**Elephant & Castle to Crystal Palace Quietway (QW7)**

**Dulwich Wood Avenue / Farquhar Road**

**Main Consultation Issues and Responses**

# QW7 – DULWICH WOOD AVENUE AND FARQUHAR ROAD

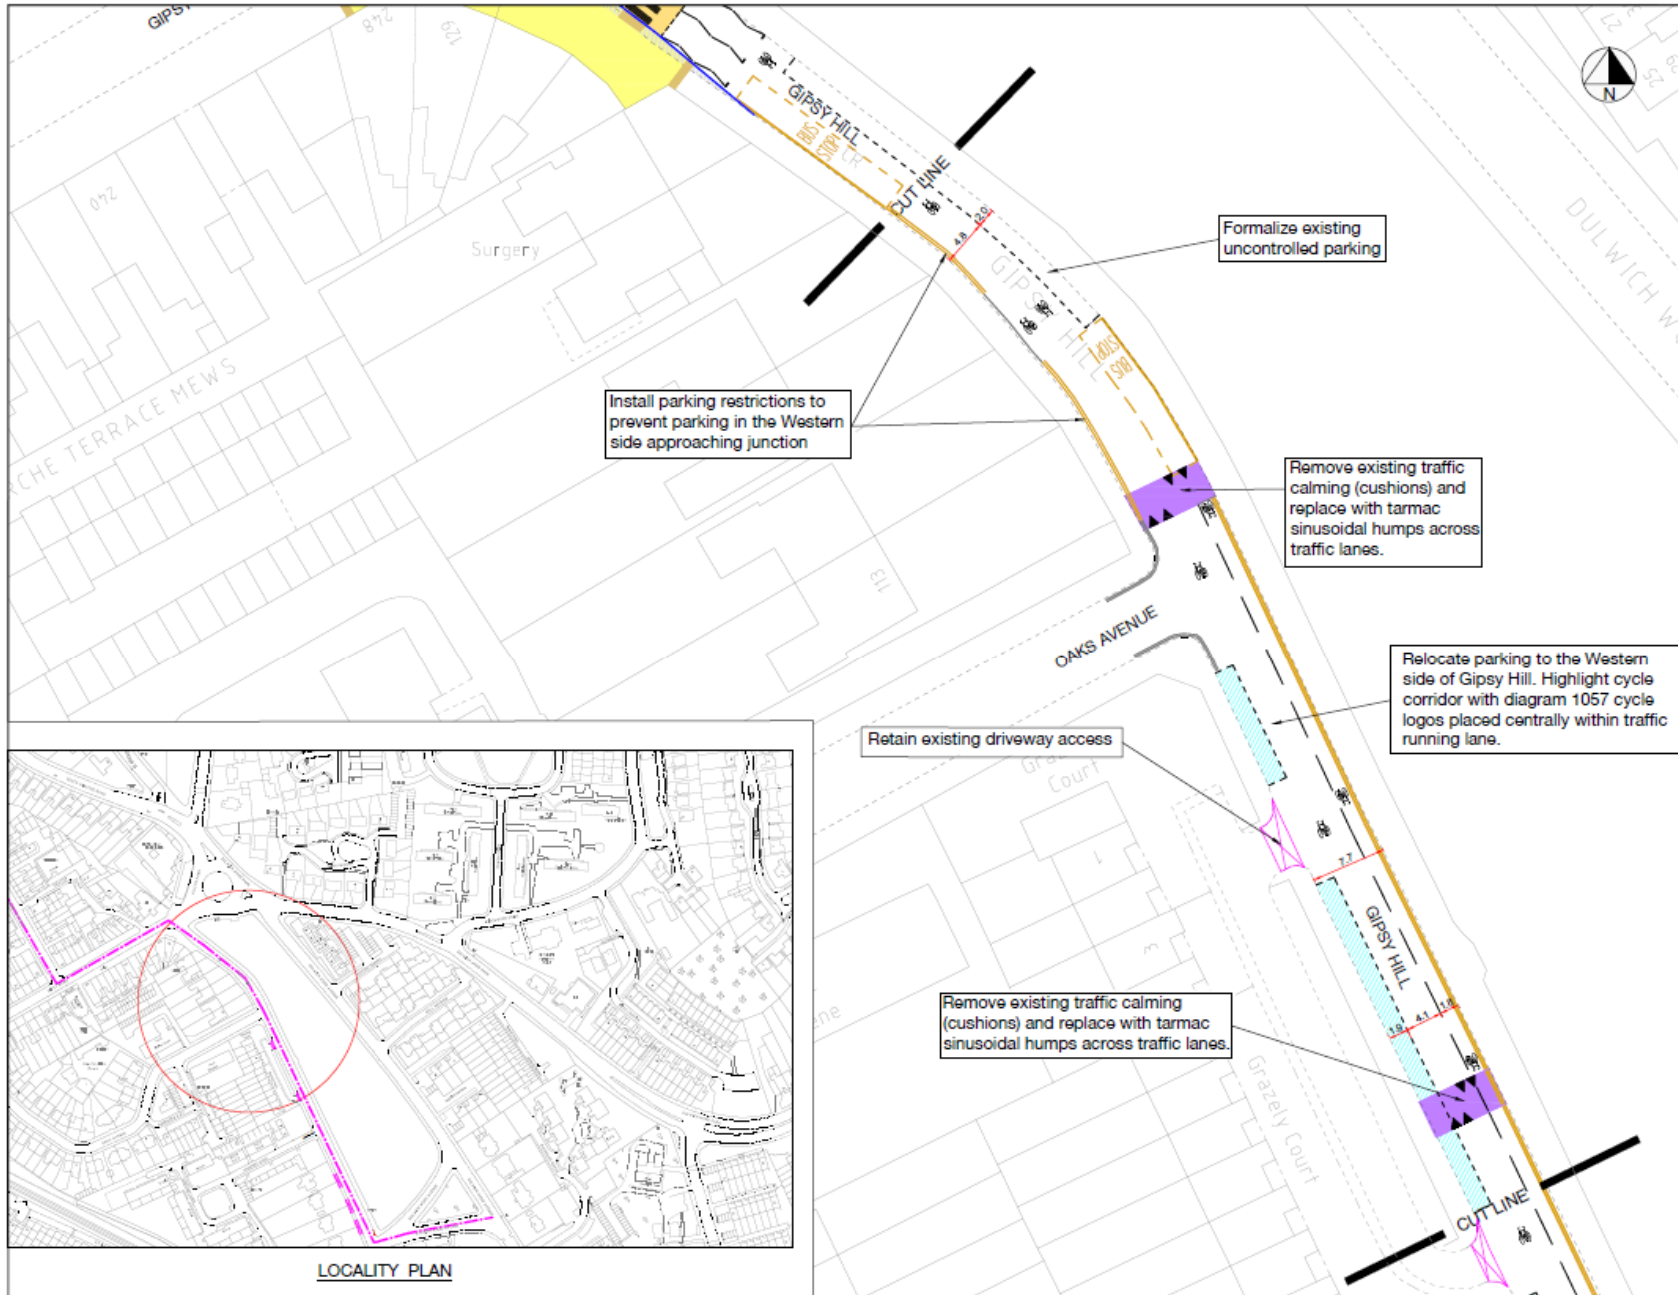
<b>Swapping of traffic islands with footway buildouts</b>	Traffic islands are safer than buildouts as they provide a two-phase crossing opportunity.	Footway buildouts reduce the time pedestrians must spend in the road or in the middle of the road. The existing traffic islands are not designed for pedestrians as they are less than 1.5m wide and do not include tactile paving. Hence, they do not provide adequate waiting widths and the provisions to accommodate large numbers of pedestrians, disabled users or parents with prams. Additionally, inappropriately parked vehicles can obstruct the visibility of pedestrians when crossing at the existing traffic islands.
	Buildouts are dangerous as they introduce conflicts among road users.	Traffic islands create pinch points and bring vehicles and cyclists into conflict, while buildouts remove this conflict. Footway buildouts also encourage cyclists to maintain the primary riding position.

<b>Removal of centre line road markings</b>	As Farquhar Road is a hill, and everyone (drivers, cyclists) speed downhill, the existing centre line marking should remain for safety.	<p>Removal of this centre line will promote safer driving behaviours, such as reduction in speeds along the route, and will support the existing 20mph speed limit.</p> <p>TfL has recently published related research highlighting the above, which can be accessed online at the following link <a href="http://content.tfl.gov.uk/centre-line-removal-trial.pdf">http://content.tfl.gov.uk/centre-line-removal-trial.pdf</a></p> <p>However, due to lack of support for this aspect of the proposals, the removal of the centre line marking will only be trialled where carriageway resurfacing will take place. Existing centre lines will be maintained elsewhere along the route.</p>

<p>For more details the use of buildouts as a traffic calming technique, refer to <i>Traffic Calming</i>, LT N 1/07, DfT (<a href="https://www.gov.uk/government/uploads/system/uploads/attachment_data/file/329454/ltn-1-07_Traffic-calming.pdf">https://www.gov.uk/government/uploads/system/uploads/attachment_data/file/329454/ltn-1-07_Traffic-calming.pdf</a>), and the <i>London Cycling Design Standards</i>, TfL (<a href="https://tfl.gov.uk/corporate/publications-and-reports/streets-toolkit">https://tfl.gov.uk/corporate/publications-and-reports/streets-toolkit</a>)</p>
<p><b>Double yellow lines at the junctions</b></p>	<p>Parking loss – Double yellow lines opposite the junctions are excessive as currently the roads are not congested and visibility around the junctions is good.</p>	<p>The extension of double yellow lines aims to improve visibility at or near junctions and reduce the likelihood of collisions occurring by removing obstructive and dangerous parking. Visibility should generally be sufficient to allow road users to see potential conflicts or dangers in advance of the distance in which they will be able to brake and come to a stop. The Highway Code (Rule 243) specifies that motorists must not stop or park opposite or within 10 metres (32 feet) of a junction, except in an authorised parking space.</p> <p>It is part of a LBS Borough-wide initiative to implement no waiting restrictions at any time (Double Yellow Lines) within 7.5 metres of a junction to ensure adequate visibility and increase safety for all road users. This addresses the conflicts between vehicles as well as vehicles and pedal cycles, and vehicles and pedestrians. It should be highlighted that obstructive parking practices and poor visibility at junctions are more dangerous for vulnerable road users, such as young children and people with disabilities.</p> <p>Proposals regarding parking restrictions have been reviewed and the proposed double yellow lines will be reduced to minimise parking loss, subject to any future road safety audits undertaken on the Quietway 7 proposals. On Dulwich Wood Avenue, the double yellow lines opposite the junctions with Rusholme Grove and Colby Road will not be introduced.</p>

<p>Please refer to the Highway Code for more information on safe parking practises <a href="https://www.gov.uk/guidance/the-highway-code/waiting-and-parking-238-to-252">https://www.gov.uk/guidance/the-highway-code/waiting-and-parking-238-to-252</a></p>
<b>New segregated cycle lanes on Dulwich Wood Avenue and Farquhar Road</b>	Light segregation (such as armadillos) should be introduced to ensure cyclist safety.	The introduction of a mandatory cycle lane will improve safety for uphill cyclists. The provision of light segregation will be considered during the completion of the design.
<b>Additional road humps</b>	Existing traffic calming is ineffective	<p>Existing speed cushions will be replaced with sinusoidal road humps which are more effective in speed reduction and encourage safer driving behaviours for all road users, including motorcyclists and drivers of large vehicles. An additional sinusoidal road hump will be introduced to ensure vehicle speeds are appropriate for the 20mph speed limit along the route.</p> <p>Please refer to <i>Traffic Calming</i>, LT N 1/07, DfT (<a href="https://www.gov.uk/government/uploads/system/uploads/attachment_data/file/329454/ltn-1-07_Traffic-calming.pdf">https://www.gov.uk/government/uploads/system/uploads/attachment_data/file/329454/ltn-1-07_Traffic-calming.pdf</a>) for more details on traffic calming techniques.</p>
